HISTORIC AND DESIGN REVIEW COMMISSION

Agenda Item No: 21

HDRC CASE NO: 2015-311
ADDRESS: 214 W LULLWOOD AVE
LEGAL DESCRIPTION: NCB 6533 BLK 13 LOT 29, AND 30
ZONING: R5 H
CITY COUNCIL DIST.: 1
DISTRICT: Monte Vista Historic District
APPLICANT: Adan Ochoa
OWNER: Michelle Nievaard
TYPE OF WORK: Amendment to New Construction of a Garage
REQUEST:

The applicant is requesting to amend a previously approved Certificate of Appropriateness at 214 W. Lullwood Ave. The requested design amendments include:

1 SOUTH ELEVATION
Scale: 1/4" = 1'-0"
GRAPHIC SCALE

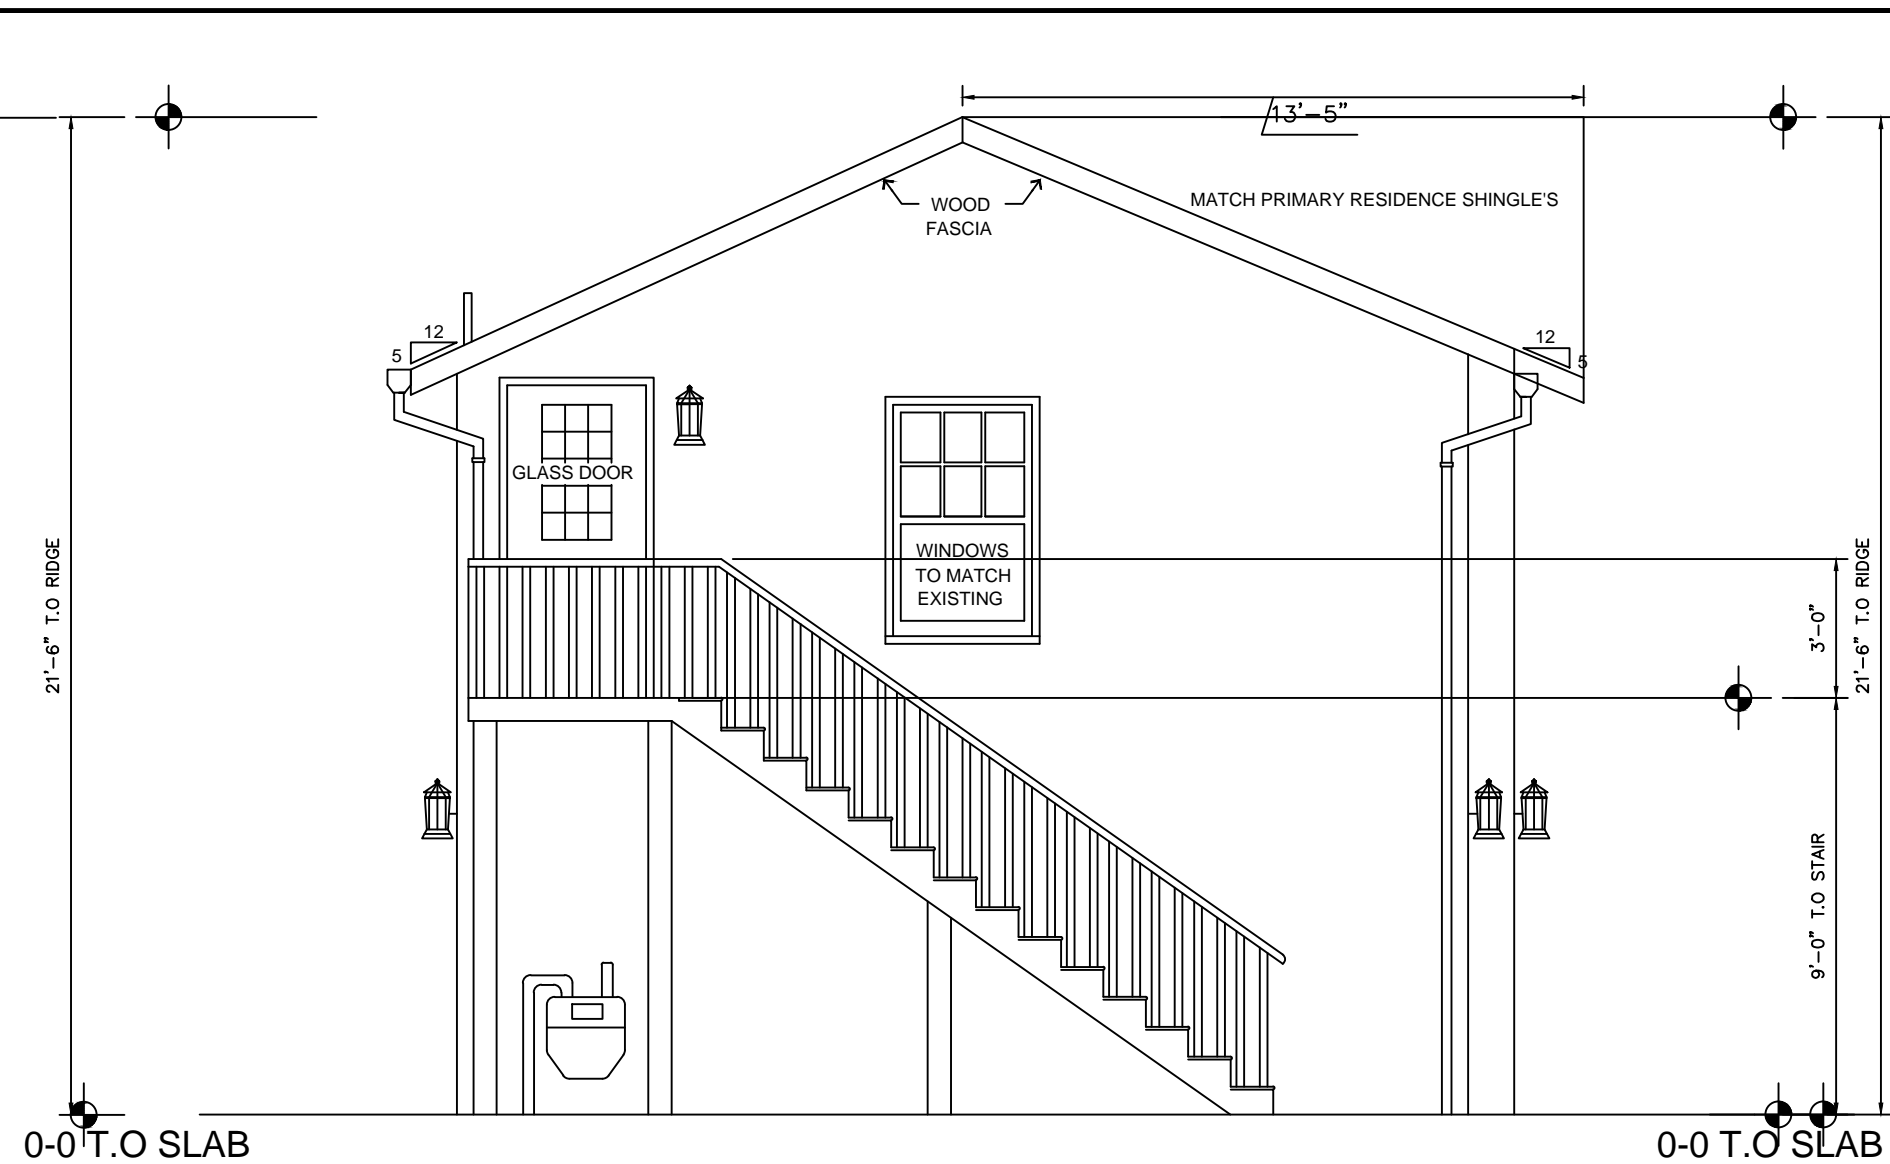
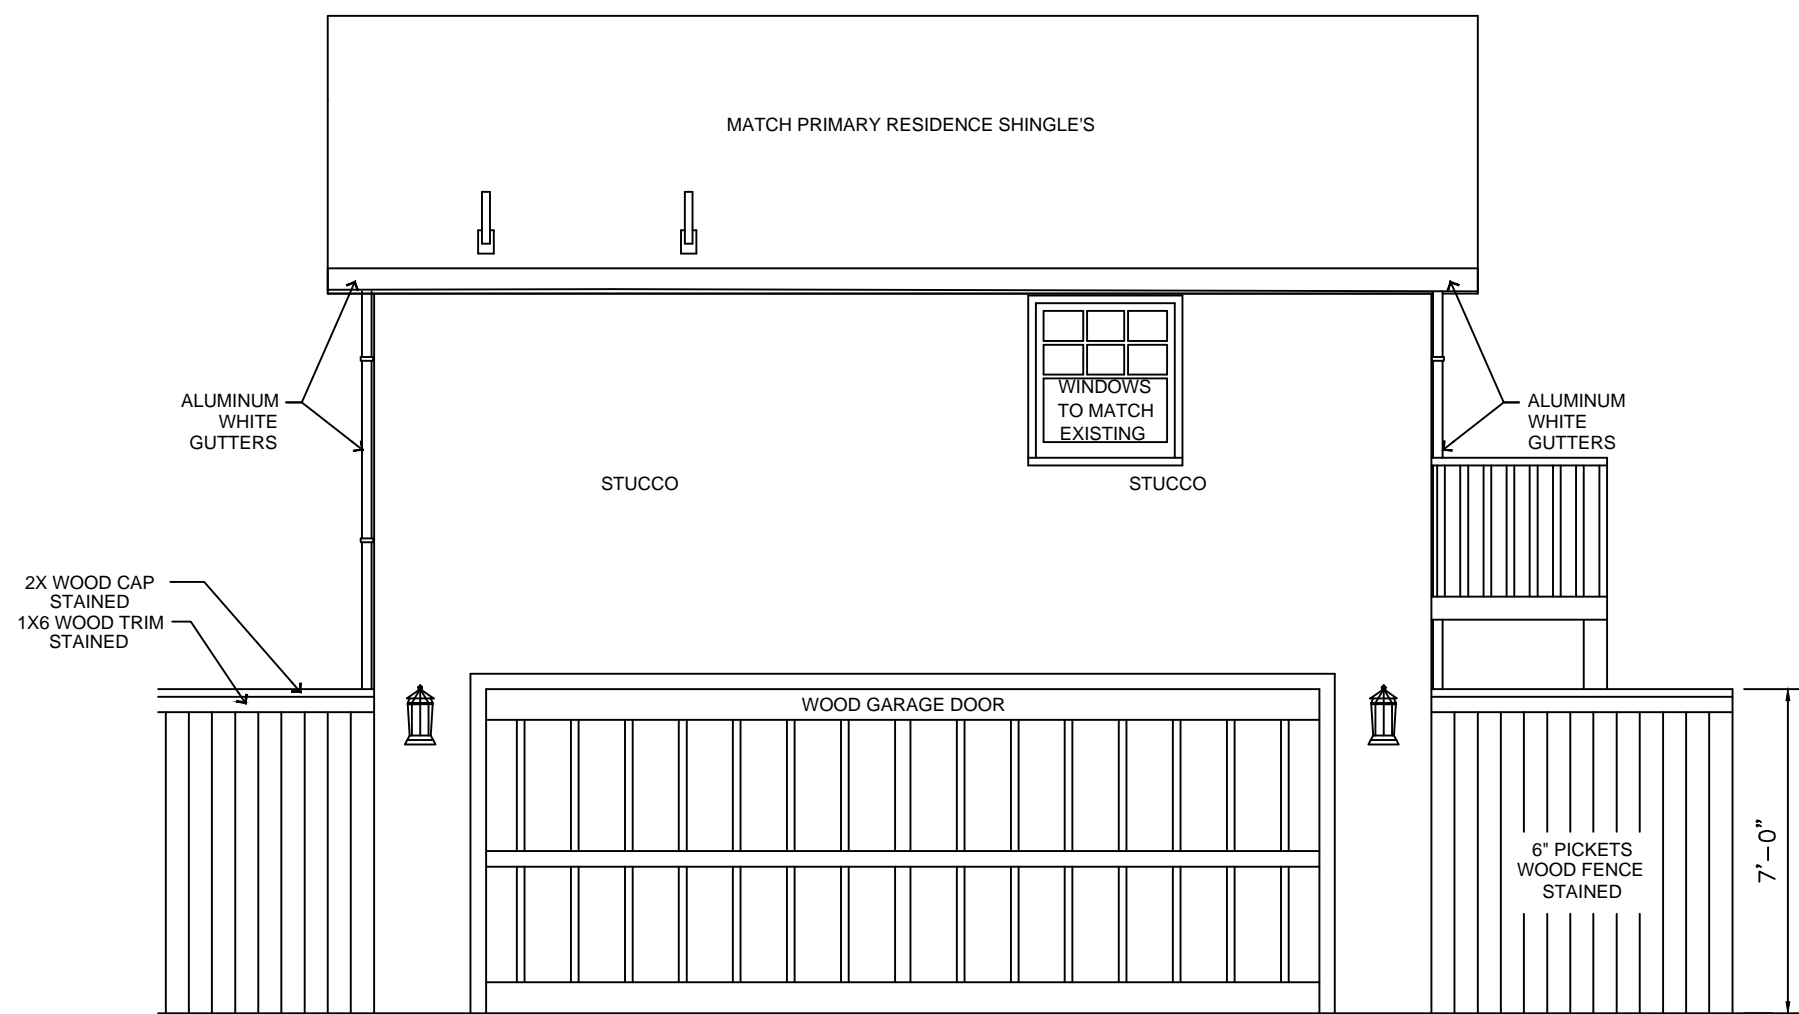
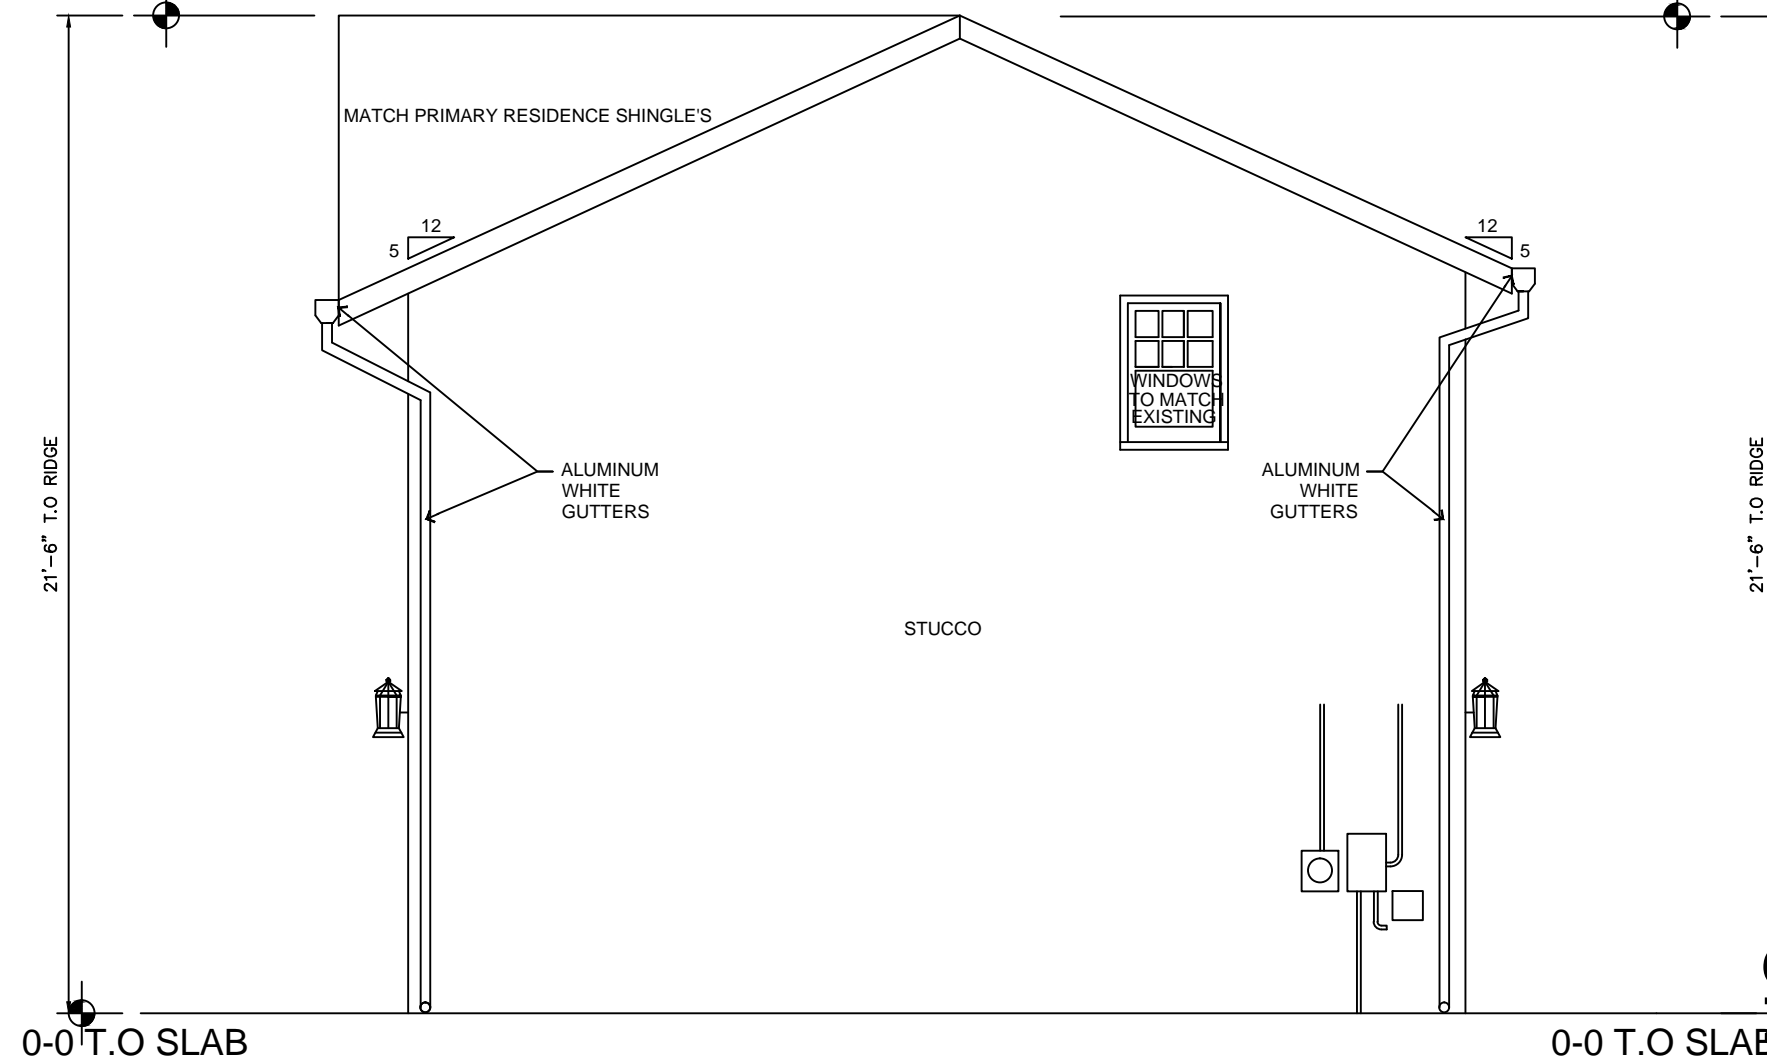
1. Moving the stairs from the west side of the structure to the east side.
2. Construct one garage opening (as opposed to two) along the alley.

- a. The applicant received approval from the HDRC for demolition and new construction of an accessory building on May 4, 2014.
- b. Consistent with the design guidelines for new construction of garages and outbuildings 4.B.i., the proposed location of the exterior stairs is appropriate and compatible with the building's orientation.
- c. The proposed garage door configuration will not feature appropriate proportions that are typically found in the district. This is not consistent with the design guidelines for new construction of garages and outbuildings 5.A.3 & 5.

Staff recommends approval of item 1 based on finding b. Staff does not recommend approval of item 2 based on finding c.
